University of Colorado – Design Review Board

Children's Hospital Colorado Loading Dock Guard Shed Presentation

DRB Comments from January Meeting

PROPOSED SITE PHOTOS

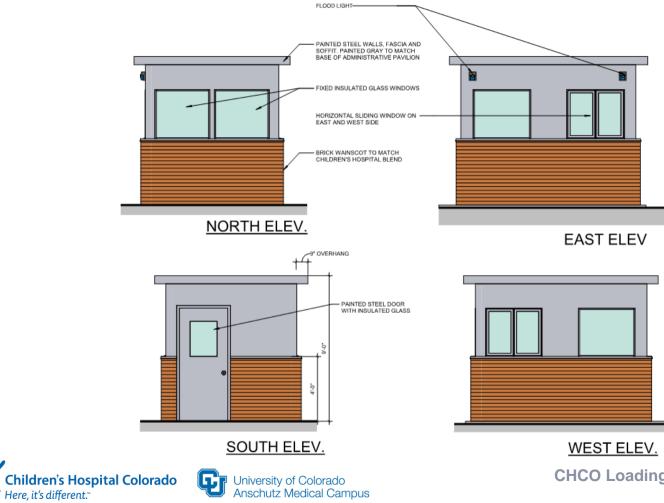
- Study site to determine the best location for the shack;
 - o Consider whether shack should be located on the right/driver's side upon entry to
 - better and more safely coordinate incoming deliveries;
 - CHCO Safety & Security Team has determined that the shed should be located west of the drive to prevent staff from crossing the drive lane out of the dock.
 - o Verify access circulation;
